Appendix G: Point Shoreline Restoration: Preliminary Feasibility Assessment

Prepared by: Jim Brennan, Marine Habitat Specialist, Washington Sea Grant
University of Washington, October 2007

ATTACHMENT A, Draft design by Lauren Perry, Bainbridge Metro Park and Recreation District

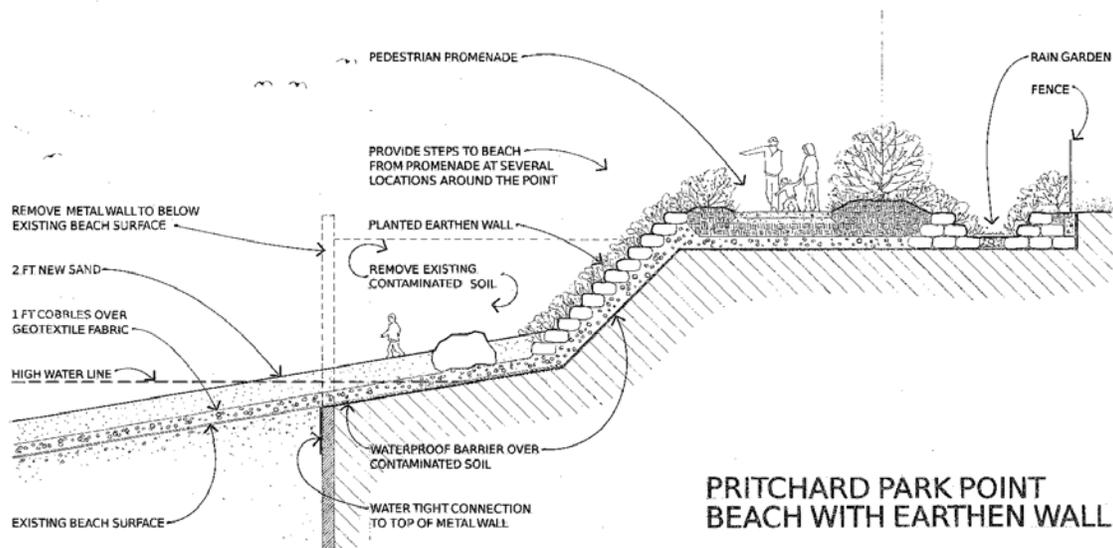
Regarding the conceptual design that was submitted for review, it is difficult to say “will work” or “won’t work” to various parts of the design because there is no scale provided. Tidal elevation is also a critical element needed for considering tidal inundation (at normal and extraordinary tidal/storm events). Beach and bank materials are also critical. The conceptual design specifies 2 feet of new sand. I would not recommend a uniform beach material, but rather a mix of sand and gravel, with size determined by the slope of the beach and wave energy that will act on those sediments. Biological considerations are also important. For example, if one of the goals is to provide spawning habitat for surf smelt and sand lance (beach spawning forage fishes), the beach material specified should be in the range of grain sizes suitable for forage fish spawning. I would not recommend the specified geotextile fabric as underlayment on the beach. This material would likely serve no purpose and would interfere with the natural colonization and survival of benthic infauna (e.g., clams, worms, etc). It is also possible that it may reduce the stability of the sediments and/or become mobile and end up as litter on the beach. The “waterproof barrier” over the contaminated sediments will be a critical element for the success of the project for containing contaminants. I do not know enough about potential impermeable materials that are available, but think that something similar to the materials that are used for liners at toxic waste sites might be suitable, if it can be sealed to the wall.

The location, height, and slope of the bank will also be very important considerations in future designs. The conceptual design suggests that a normal high tide would not touch the bank, but may during a storm. This is a very important consideration. Beach slope and material are important for dissipating wave energy and the bank should be

In addition to the comments above, some consideration may be given to cutting the sheet pile wall slightly higher than depicted in the conceptual drawing; leaving a sill that either matches post-construction beach grade, or is slightly higher than post-construction grade (i.e., after the beach sediments are added). This would help retain some of the beach sediments and might help assure retention of contaminants. It may also serve as an anchor for logs to be installed, but may be located too far waterward. Some thought needs to go into this option because there would also be the risk of having an exposed structure that could be a hazard to beach walkers.

One element of a beach restoration design that is not included in the conceptual drawing is the incorporation of a beach berm. If the elevations are appropriate, the creation of a berm could help reduce the steepness of the bank and serve to protect the bank. It could also serve as a sediment source for the beach in the event of a severe storm. The berm would be composed of large wood, sand/gravel mix, and vegetation. Berms are a natural
